Dear Reviewers, dear Editor,

Reviewer 1

Reviewer 2 (Martin Mergili)

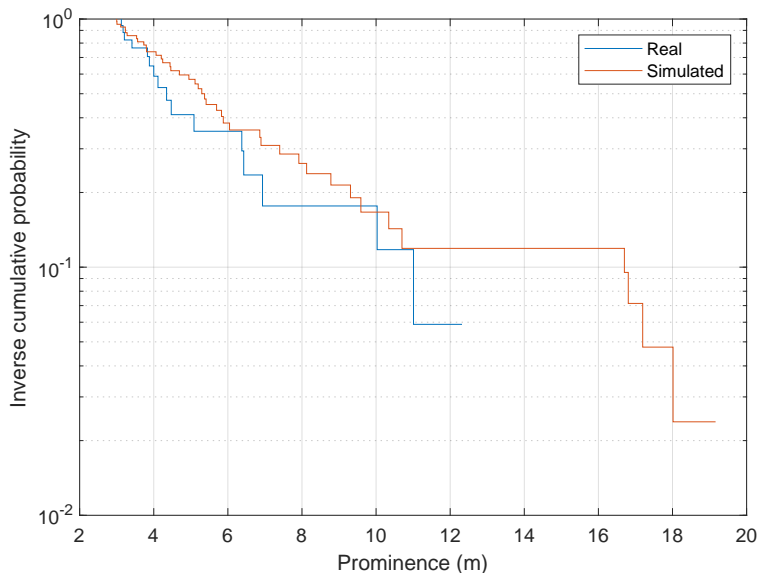
The biggest hills in the simulation is bigger than the real toma hills. How does the total number of toma hills and distribution compare between both simulation and reality?

Originally, I wanted to stay on a more qualitative level and did not include any results about the size distribution. It seems that the prominence follows an exponential distribution (see figure) with little difference between simulation and real topography, but I am uncertain about its interpretation. **I added some results about the distributions in (lines 109–111 and 118–119),** but without going into details.
